U.S. Department of the Interior  
BUREAU OF LAND MANAGEMENT

<b>Well Name:</b> POKER LAKE UNIT 13-1 PC	<b>Well Location:</b> T24S / R29E / SEC 13 / SENE / 32.218561 / -103.932621	<b>County or Parish/State:</b> EDDY / NM
<b>Well Number:</b> 708H	<b>Type of Well:</b> OIL WELL	<b>Allottee or Tribe Name:</b>
<b>Lease Number:</b> NMNM05912	<b>Unit or CA Name:</b> POKER LAKE UNIT	<b>Unit or CA Number:</b> NMNM71016X
<b>US Well Number:</b>	<b>Operator:</b> XTO PERMIAN OPERATING LLC

**Notice of Intent**

**Type of Action:** APD Change

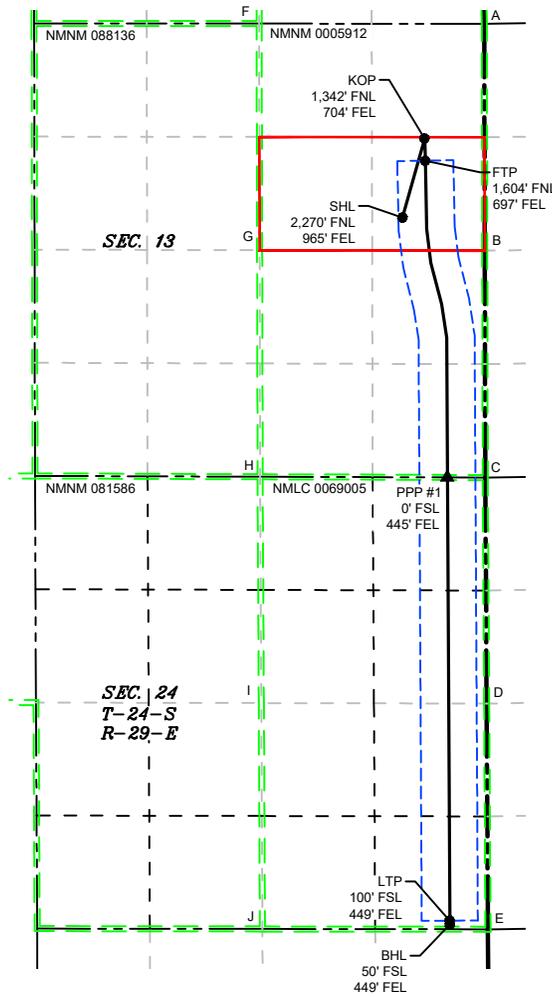
XTO Permian Operating, LLC. respectfully requests approval to make the following changes to the approved APD. Changes to include KOP, FTP, proposed total depth, and pool.

KOP: 2270 FNL & 965 FEL OF SECTION 13-T24S-R29E 1342 FNL & 704 FEL OF SECTION 13-T24S-R29E  
FTP: 2059' FNL & 449' FEL OF SECTION 13-T24S-R29E 1604' FNL & 697' FEL OF SECTION 13-T24S-R29E

The proposed total depth is changing FROM 18237 MD; 9194 TVD TO 18211 MD; 9192 TVD.

Pool code is changing FROM Pierce Crossing; Bone Spring, East (96473) TO Wildcat S243006B; LWR Bone Spring (97753) & Pierce Crossing; Bone Spring (96473).
